DART SERVICE INSTRUCTION

TO AMEND INSTALLATION INSTRUCTIONS IIN-D119-756 REV. C & INSTRUCTIONS FOR CONTINUED AIRWORTHINESS ICA-D119-756 REV. 0
REF. TCCA STC SH06-39
REF. FAA STC SR02364NY
REF. EASA STC EASA.IM.R.S.01289

FIGURE 1 - D119-756-041 HELI-UTILITY-BASKET

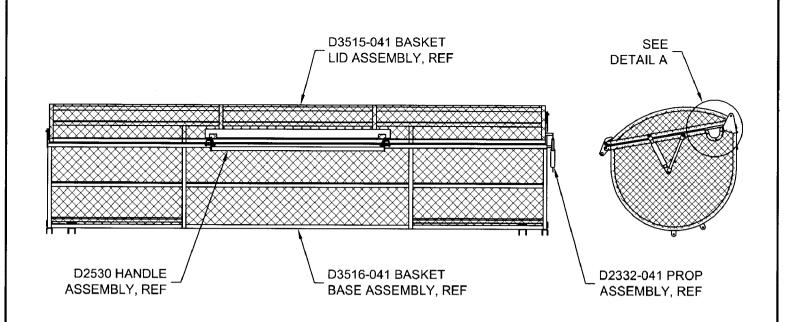
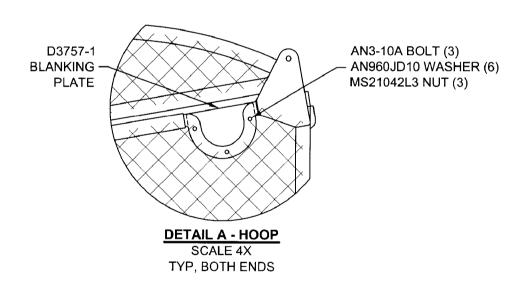
ON THE D119-756-041 HELI-UTILITY-BASKET AT CHG 002 OR LATER, THE FORWARD AND AFT ENDS OF THE D3516-041 BASKET BASE ASSEMBLY HAVE BEEN UPGRADED WITH HOOPS AND FITTED WITH D3757-1 BLANKING PLATES. THE D3757-1 BLANKING PLATES MAY BE REMOVED TO ALLOW THE OPERATOR TO RUN A CABLE OUT OF THE BASKET TO THE AIRCRAFT. IT IS THE RESPONSIBILITY OF THE OPERATOR TO ENSURE THAT THE CABLE IS PROPERLY SECURED FOR FLIGHT. REFER TO FIGURE 1 ON SHEET 2 OF THIS SERVICE INSTRUCTION.

THE PARTS LIST ON PAGE 14 OF IIN-D119-756 REV. C AND ON PAGES 41 AND 43 OF ICA-D119-756 REV. 0. SHOULD BE UPDATED AS FOLLOWS:
